FILE P.I. No. 0008275, Chatham County
CSMLP-0008-00(275)
SR 21 at CR 9/Crossgate Road/Gulfstream Road -
Intersection Improvements

SUBJECT APPROVED PROJECT CONCEPT REPORT

SUBJECT: *PROJECT CONCEPT REPORT*

SUBJECT: PROJECT CONCEPT REPORT REVIEW

PREFERRED ALTERNATE
 INTERSECTION IMPROVEMENT OF
 SR 21 @ GULFSTREAM ROAD -
 CROSSGATE ROAD

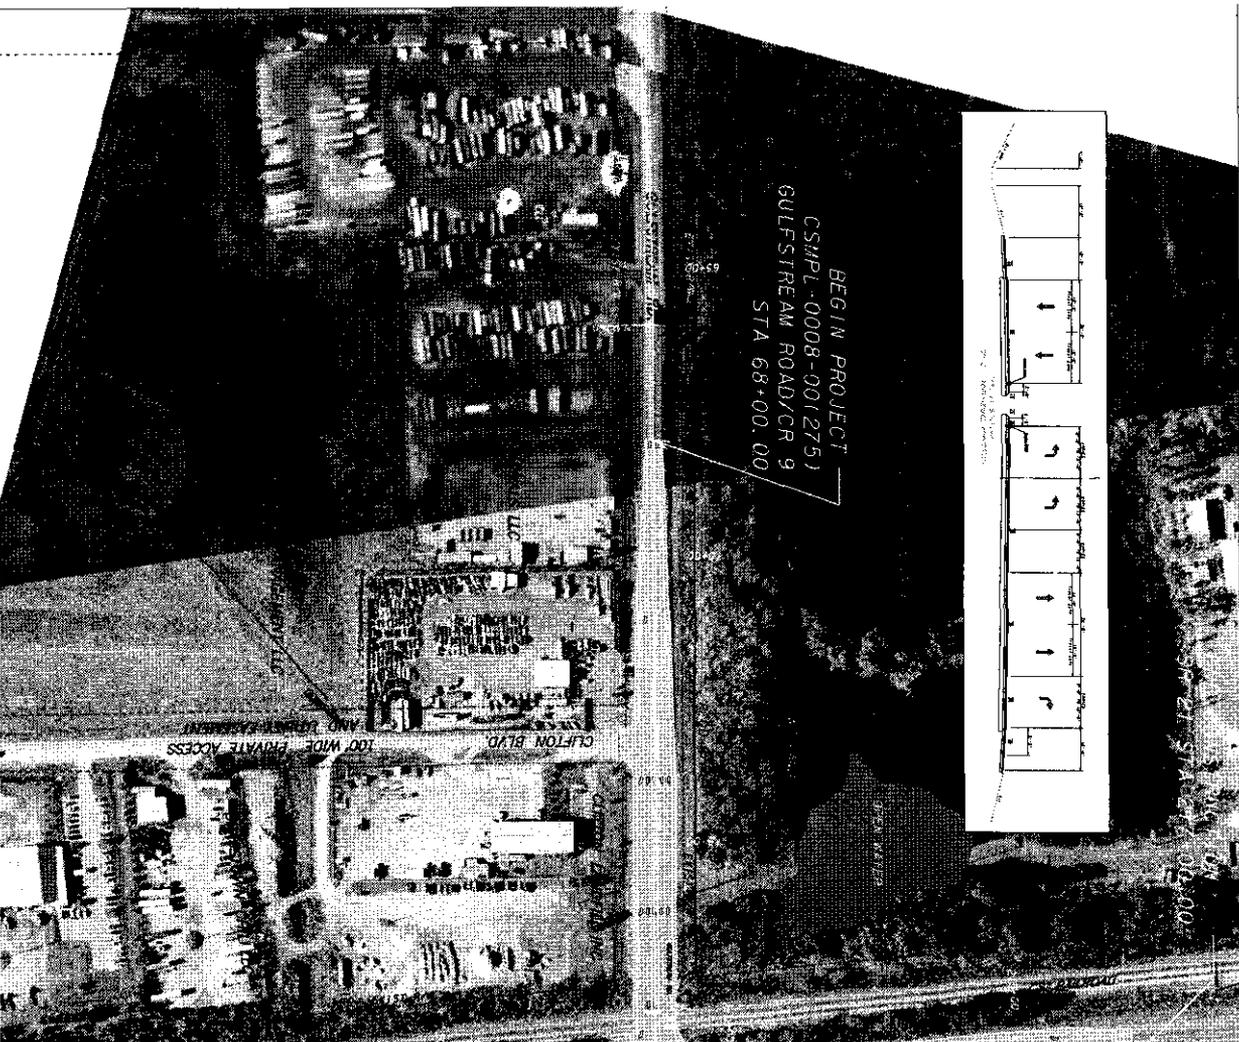
- Brad Saxon, GDOT, pointed out that the concept report on Page 6 indicates that there is no curb and gutter on Crossgate Road; however, the concept layout showed curb and gutter on both the northeast and southeast quadrants. Parsons agreed to revise the concept report to eliminate this discrepancy.

- Cynthia Philips, GDOT, indicated that GDOT will likely request crosswalks at all approaches to the intersection. This will move the stop bars back, resulting in insufficient storage space for tractor trailers between the new stop bar and the CSX Railroad at grade crossing on Gulfstream Road. Parsons will look into this condition to study further and agreed to reflect this change in the final concept layout as well as preliminary design if needed.
